CITY of NOVI CITY COUNCIL

Agenda Item 2
June 2, 2014

SUBJECT: Consideration of a request from Mirage Development, LLC for a variance from the following ordinance sections: 1) Subdivision Ordinance Section 4.05(A) requiring that pedestrian safety paths be constructed along both sides of local streets (a sidewalk on only the north side is proposed), 2) Section 11-94(c) to provide less than three feet of cover for storm sewer pipe, 3) Section 11-194(a)(7) for exceeding the 800 foot maximum length of a cul-de-sac (975 feet is proposed), 4) Section 11-194(a)(19) for the lack of a secondary or emergency access; as part of the site plan for Orchard Hills North single family residential development (parcel 22-26-201-006).

VARIANCE REQUESTS PLAN
 ORCHARD HILLS NORTH CONDOMINIUM
 PART OF THE N.E. 1/4 OF SECTION 26,
 T.1 N., R.8 E., CITY OF NOV, MI
 OAKLAND COUNTY, MICHIGAN

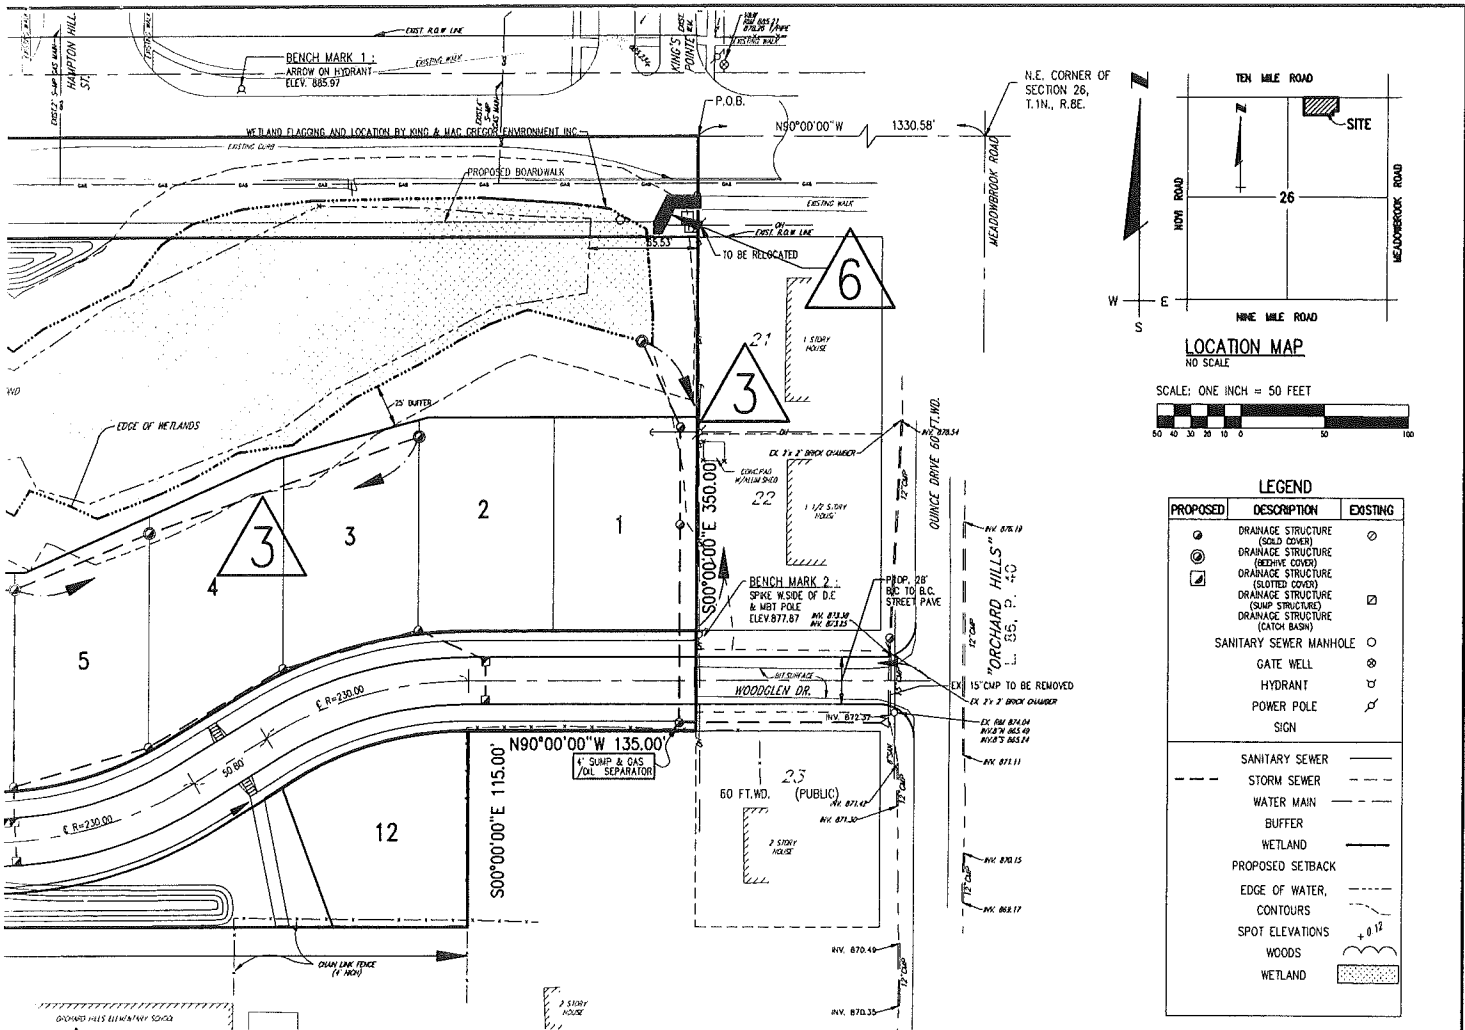
1. A City Council waiver for having a sidewalk on only one side of Woodglen Street:
 - This waiver was granted by City Council on 11-14-05.
 - The reason for this request is that the sidewalk would serve no purpose, as there are no homes for the sidewalk to serve.

2. An administrative variance from Appendix C, Section 4.04(A)(1) for not providing stub street to adjacent school property.
 - The school site was developed with their access provided on the south side of their building.

3. A City Council variance is requested from Section 11-94(C) for providing less than three feet of cover for storm sewer pipe.
 - The reason for this request is that there are several runs of storm sewer which, in order to outlet to the sediment basin, cannot be placed to provide the three feet of minimum cover. Additional fill cannot be placed due to their location and topography.

4. A variance is requested from City Council from Section 11-194(a)(7) for exceeding the 800 foot maximum length for a cul de sac.
 - Previously granted 11/14/05.

- The reason for the request is due to the practical difficulty caused by the topographical and natural features of the site. Further, this proposed street is single loaded with homes on only one side of the street. The concept of limiting the length of the cul de sac street is the limit the number of units to between 20 and 30; this site is proposing only 12 units.

5. A variance is requested from City Council from Section 11-194(a)(19) for units in excess of 800 feet external access.
 - Previously granted 11/14/05.

- The reason for this request is that there are no places to provide external access due to the topographic and natural features of the site. In addition, the property to the west is an apartment complex with private drives and the property to the south is the school. As with the request for exceeding the 800 foot maximum cul de sac length, there will be only 12 proposed units.

6. A variance is requested from City Council from Section 11-258(a) for a bicycle path more than (1) foot away from future right-of-way lines.
 - Previously granted 11/14/05.
 - The reason for the request is that, in order to tie into an existing walk at the N.E. corner of the site, the path needs to be more than the (1) foot as required.
